Riley Purgatory Bluff Creek Watershed District Permit Application Review

Permit No: 2021-085

Project: 7851 Park Drive Storage Expansion: Proposed addition of an approximately 8,100 SF outdoor gravel storage area and a one-way concrete drive entrance. Proposed stormwater feature includes an infiltration swale to provide stormwater rate, volume, and quality control. Because infiltration testing results indicate the infiltration capacity of the soils on the site are between 0.29-0.42 inches per hour (in/hr) which is higher than used in the design, the applicant has submitted this permit modification request to change the stormwater management facility from an iron enhanced sand filter with elevated drain tile to an infiltration swale.

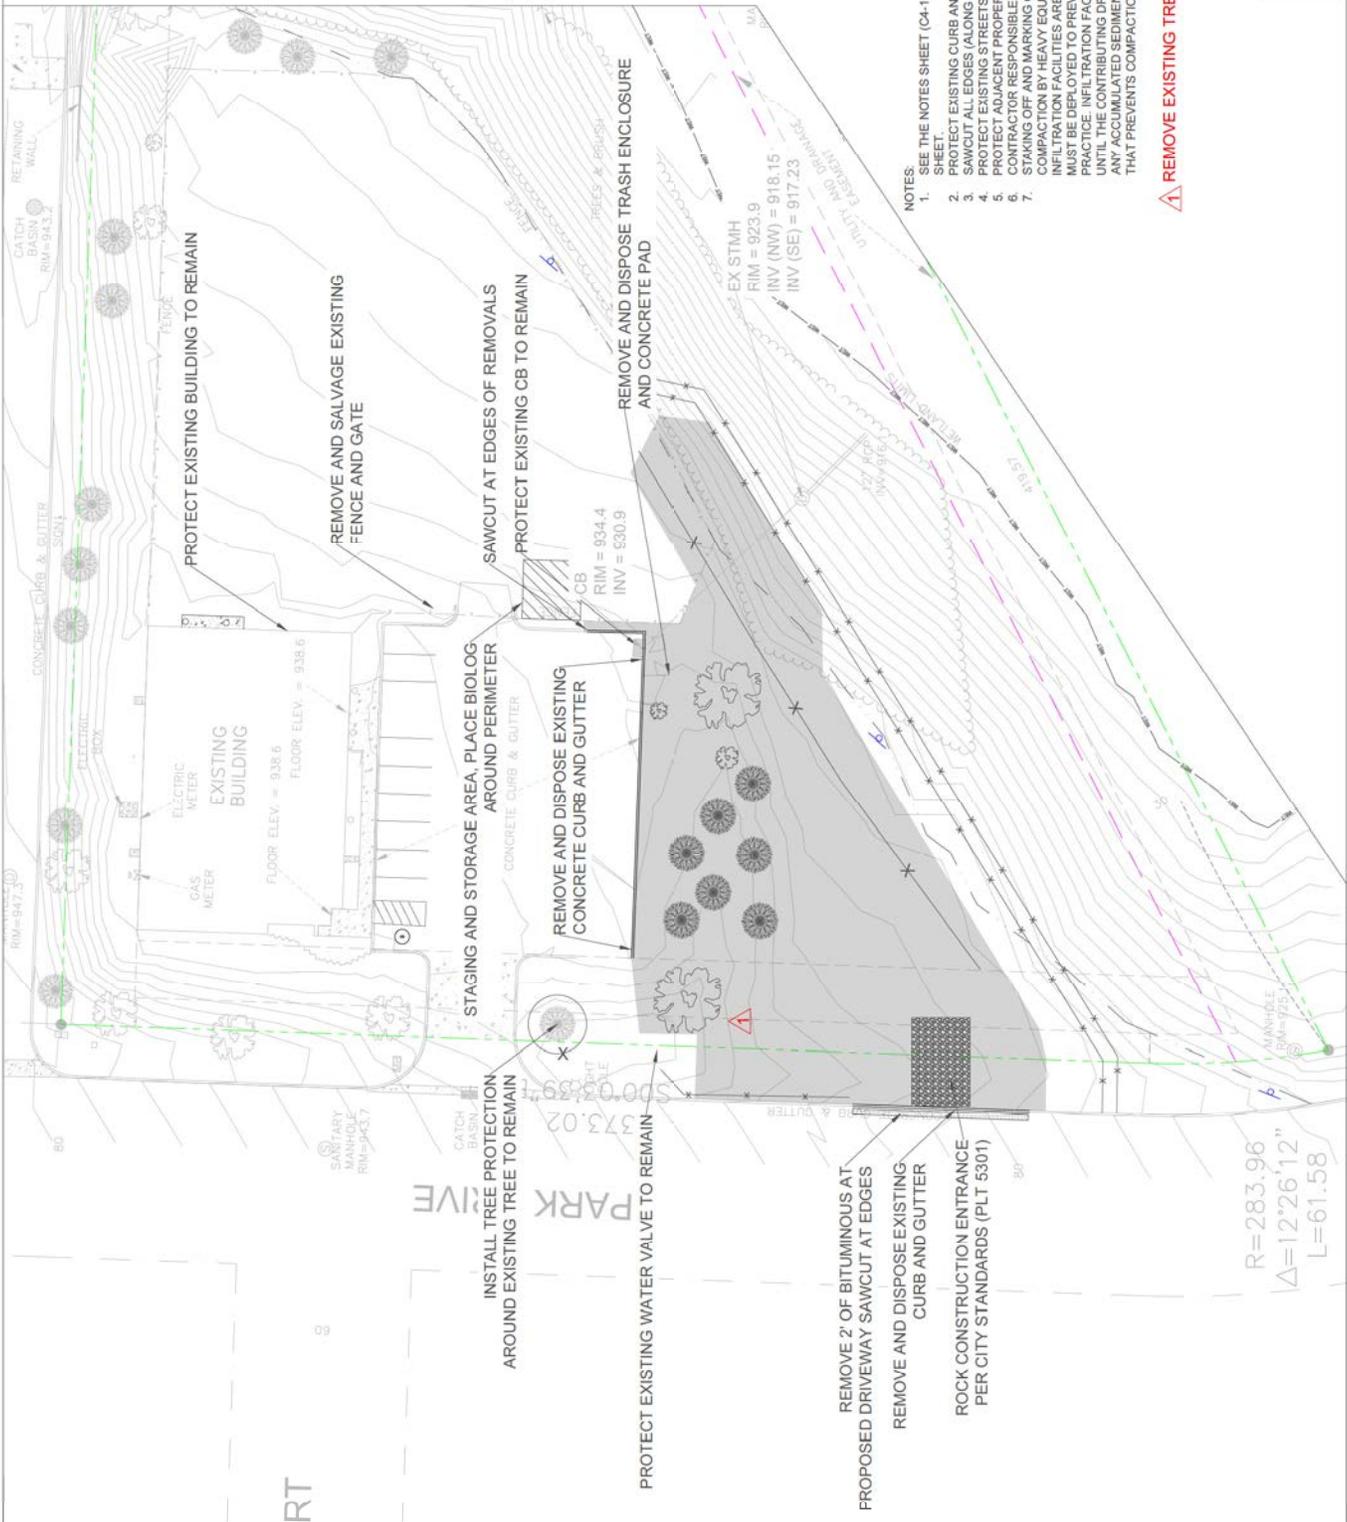
REMOVE EXISTING TREE

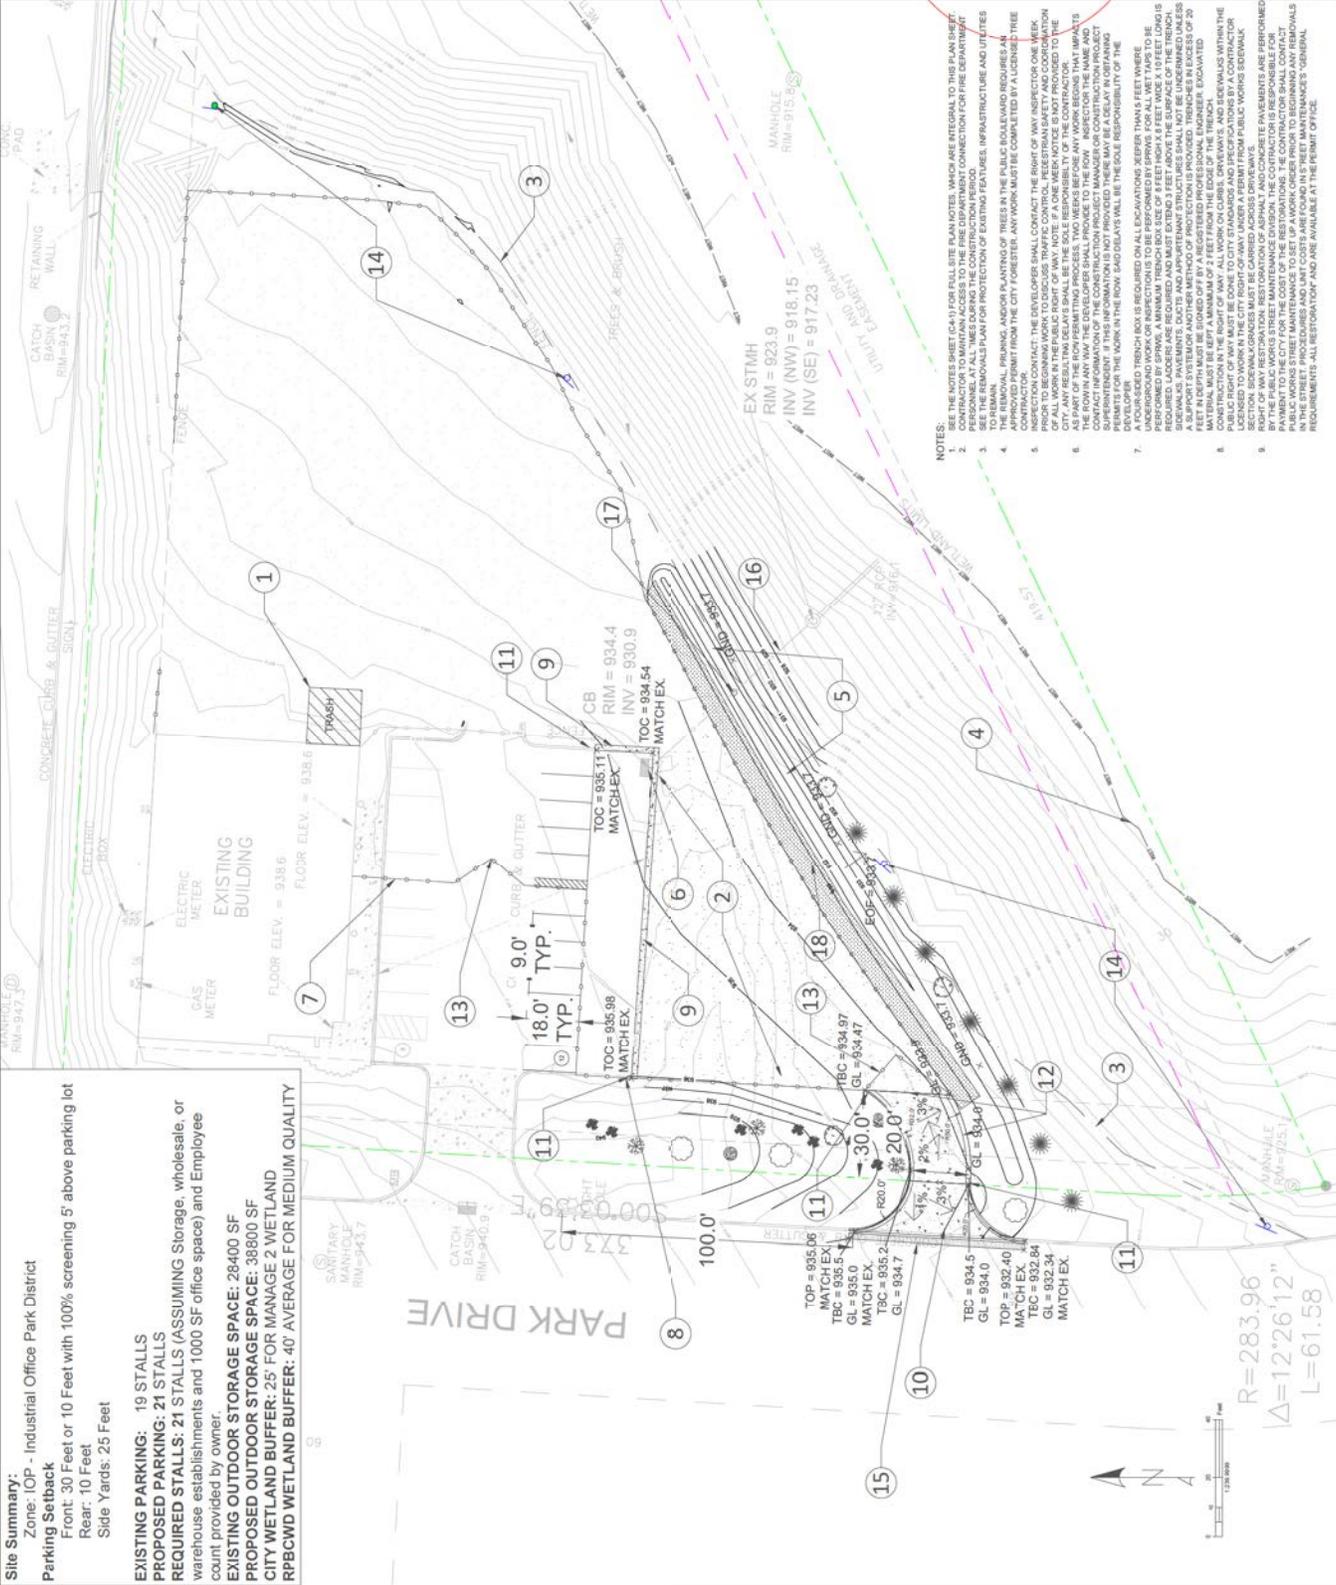
MODIFIED RISER STRUCTURE
 REMOVED DRAINITE IN FILTRATION SWALE

▲ ADDITIONAL TREE TO REPLACE EXISTING
